**ADDENDUM NO. 1**

**South River Fish Passage and  
Veterans Memorial Park Improvements Project  
Marshfield, MA**

September 6, 2024

**ADDENDUM NO. 1**

**FLOW CONTROL STRUCTURE DETAILS**

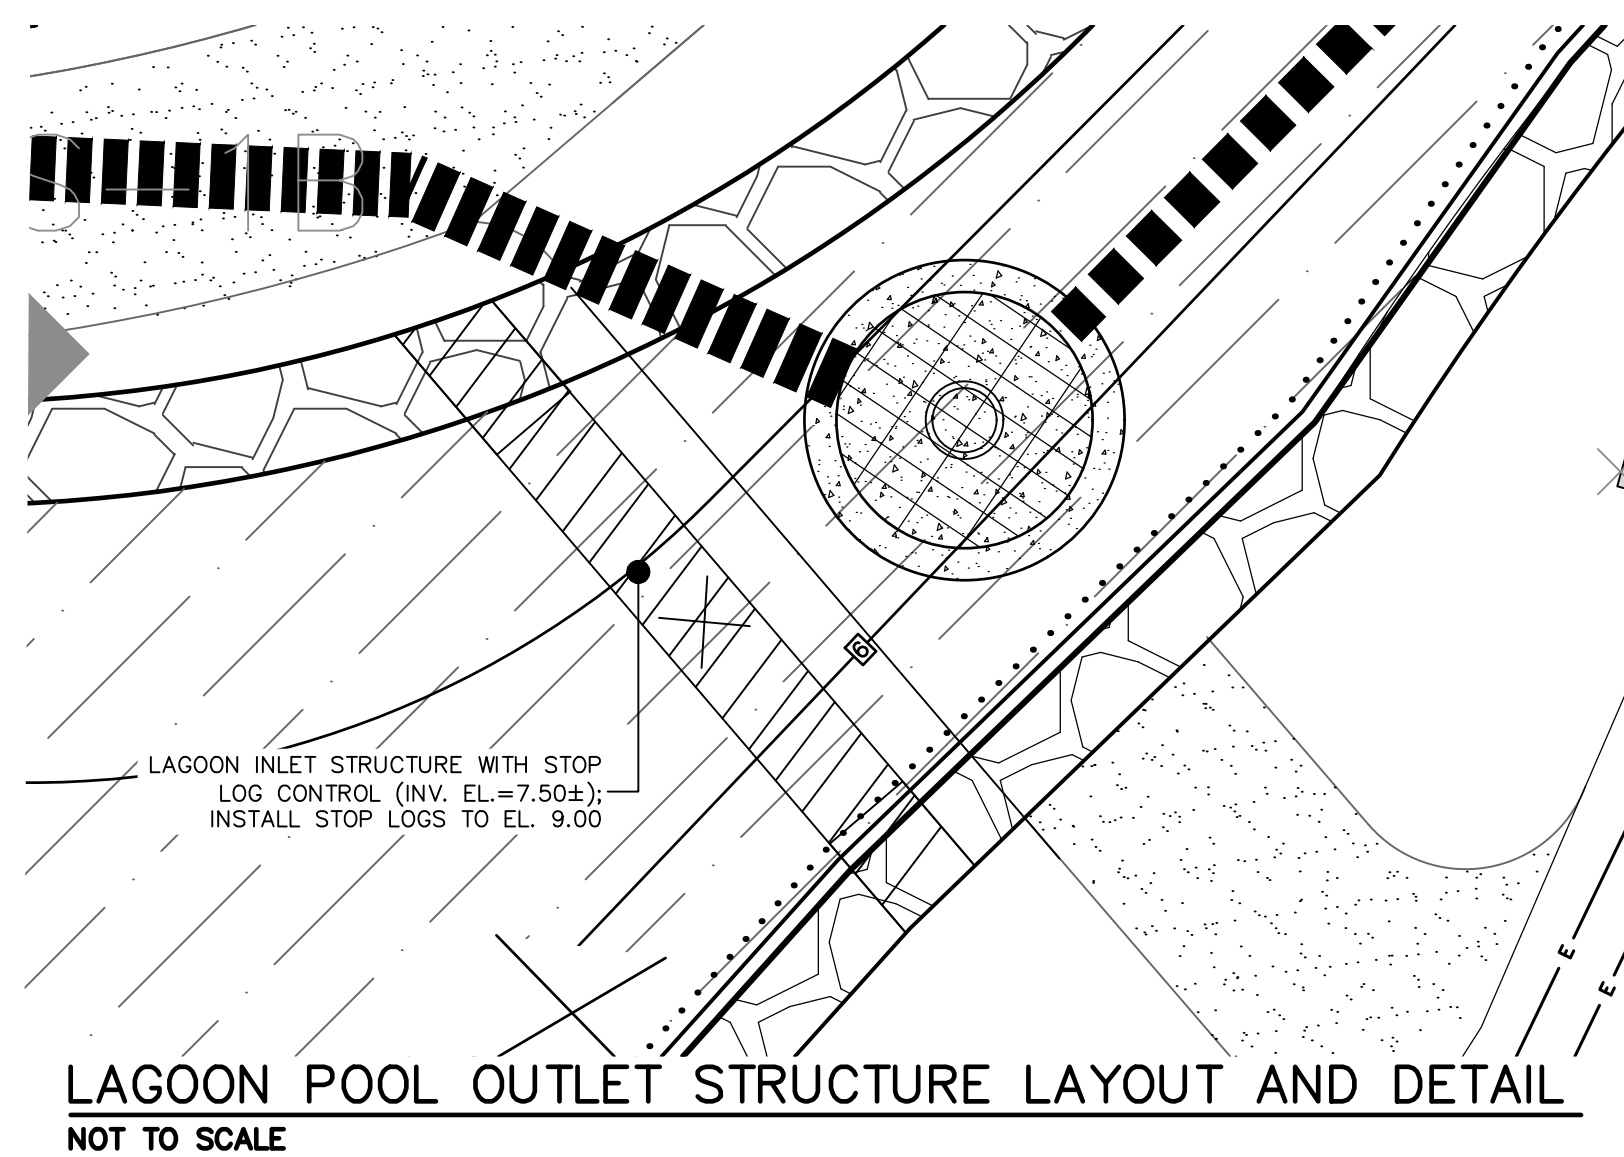
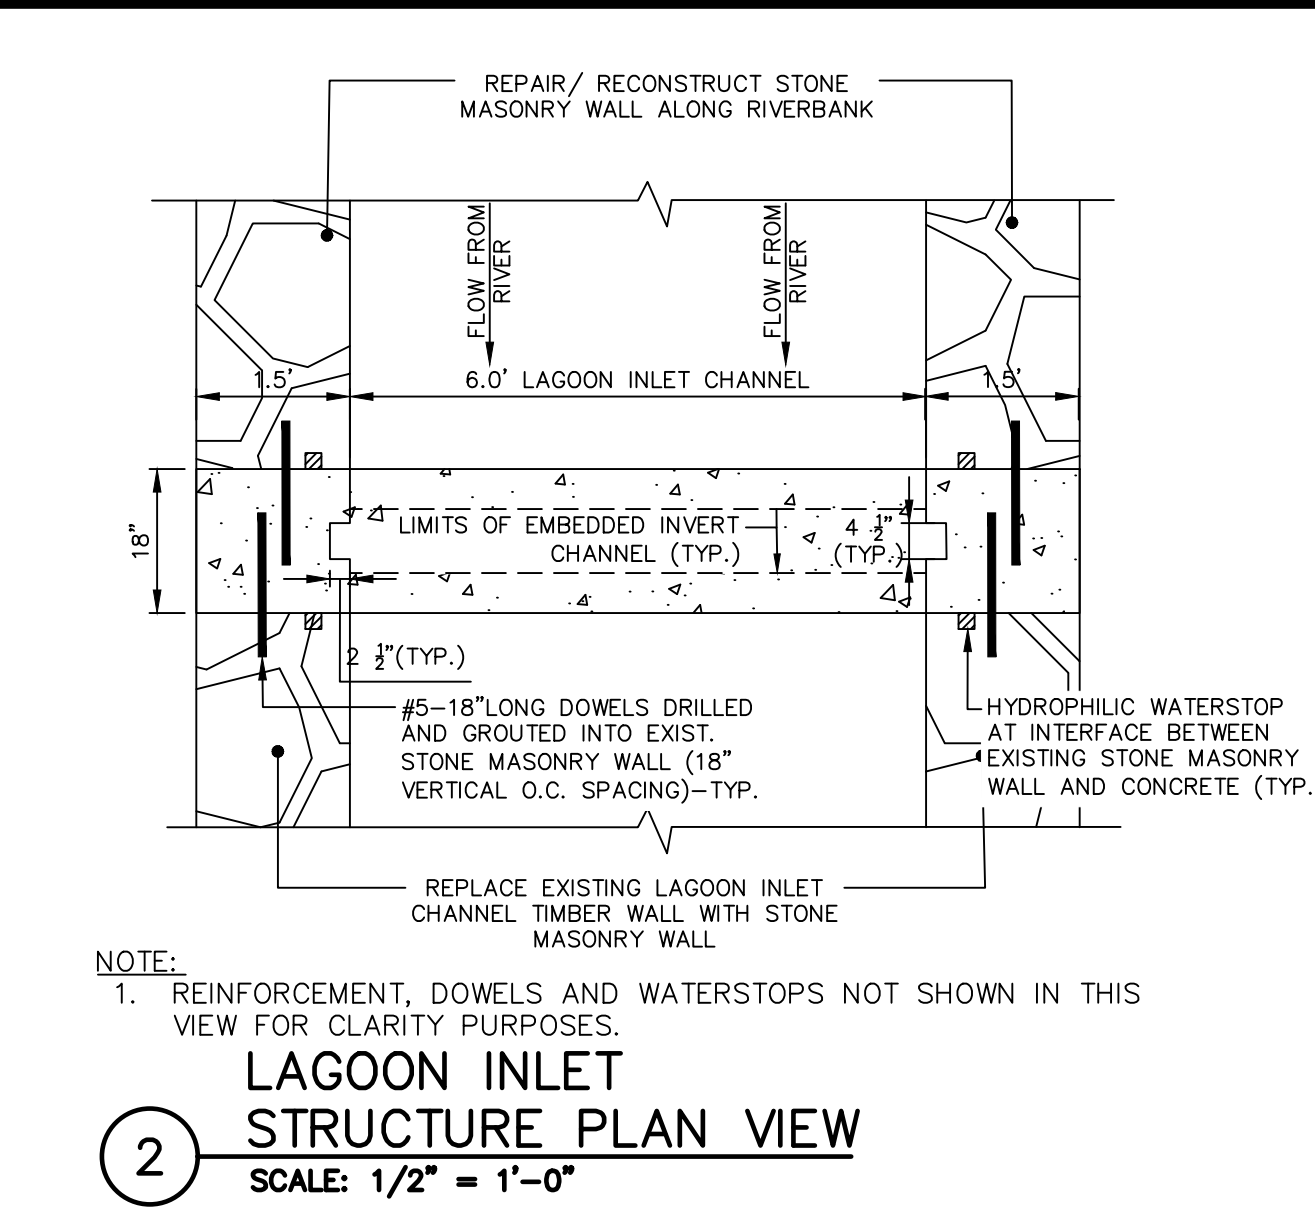
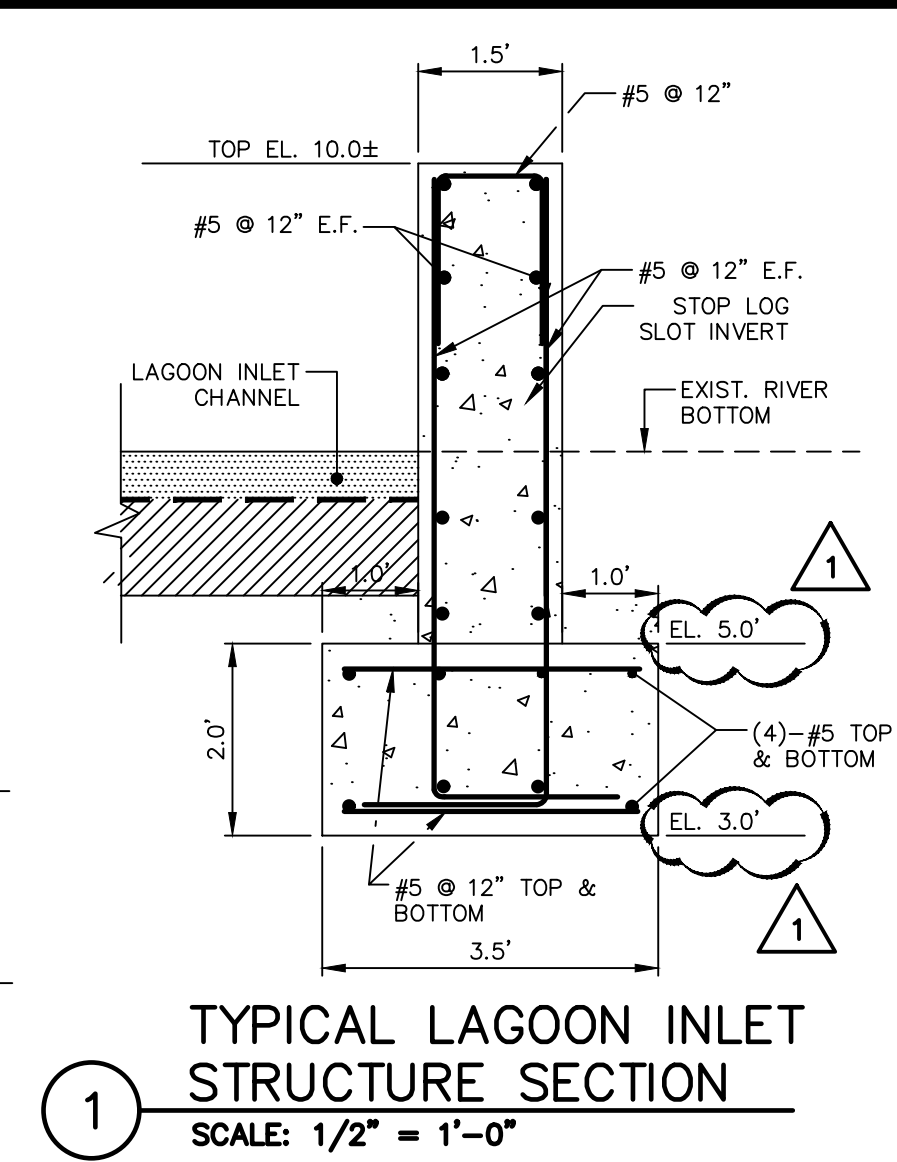
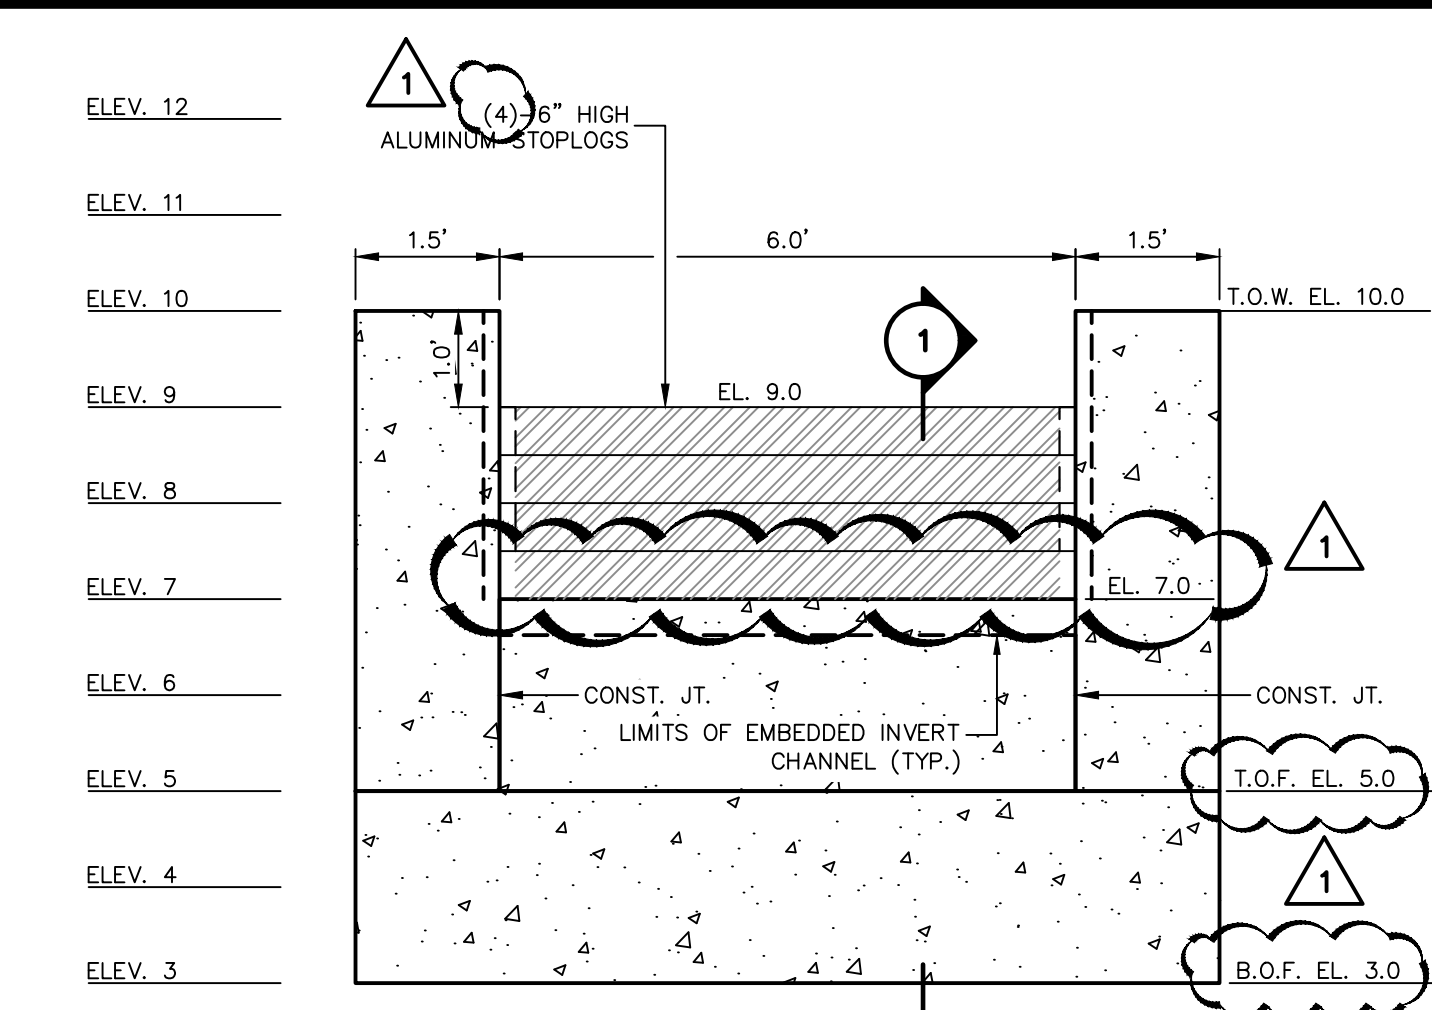
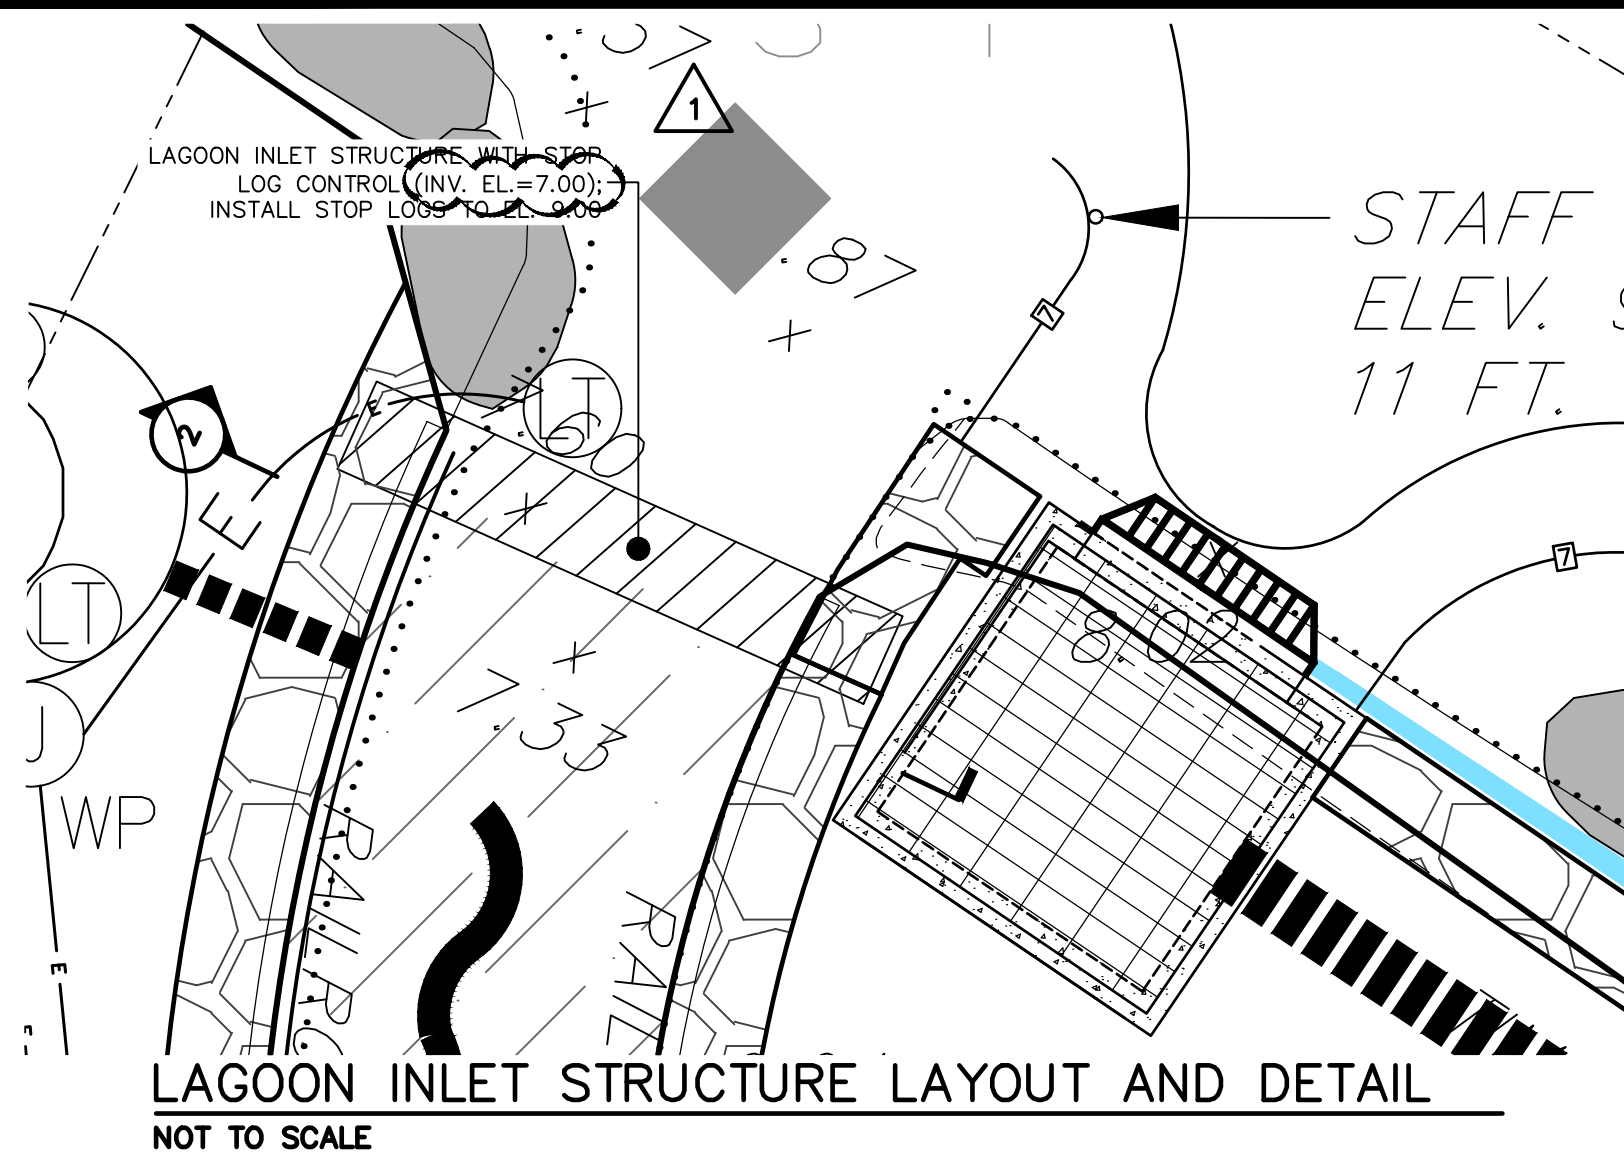
14. Delete *Section 33 37 00 – Flow Control Structures* in its entirety and replace with the revised Flow Control Structures specification provided in Attachment F.
  - A. General changes include, but are not limited to, deleting gate and frame requirements and replacing them with stop gate and frame requirements.

- STOP GATE NOTES:**
1. STOP GATE SHALL BE ALUMINUM (ALLOY 6061-T6) WITH STAINLESS STEEL STEMS AND HARDWARE ALONG WITH FLEXIBLE ULTRA HIGH MOLECULAR WEIGHT (UHMW) SEAT/SEALS WITH A RESILIENT BOTTOM SEAL (MODEL 501 AS MANUFACTURED BY WHIPPS, INC. OR APPROVED EQUAL).
  2. GATE FRAMES SHALL BE EMBEDDED IN CHANNEL WALLS.
  3. STEEL REINFORCEMENT NOT SHOWN FOR CLARITY.
  4. PROVIDE MECHANISM TO LOCK STOP GATE IN THE OPEN POSITION AT VARIOUS ELEVATIONS.
